PLED Driver Case Improvements

Changes to the case design of LED drivers can functionally improve performance.

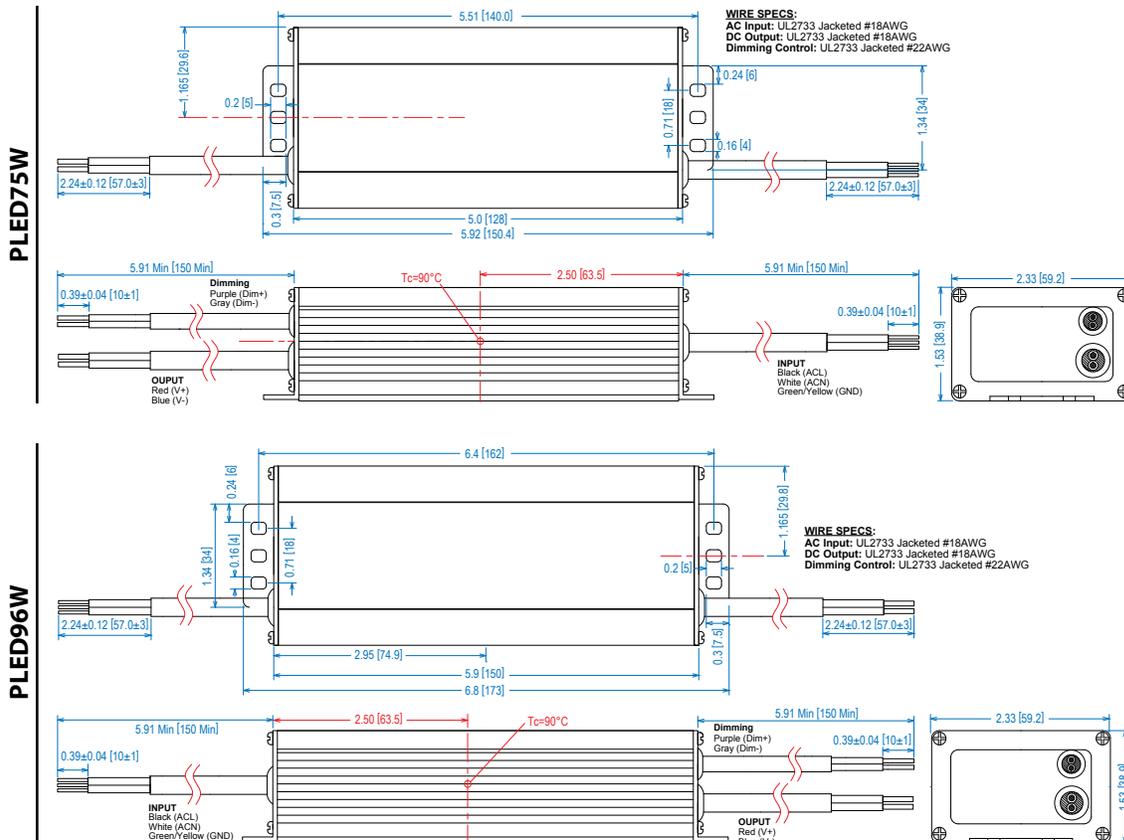
- The bottom side of the case now has a **smooth, uninterrupted surface**. This allows for full contact with a metal housing or metal bracket, improving transfer of heat away from the driver, and prolonging life.
- The mounting flange on each end is now **slightly offset** from the bottom of the driver, to help ensure that the driver makes full contact when it is screwed in place.
- All input and output wires have been **relocated to one side** of the driver. This ensures that they do not interfere when inserting screws to mount the driver in place, and also makes fixture wiring more consistent.
- A **new center hole** is also provided on each flange in addition to the existing holes, providing a new option for securing the driver in place.

Note: The new case height is 0.06 IN [1.6mm] taller than the previous rev model. For complete product details, please see the individual data sheets.
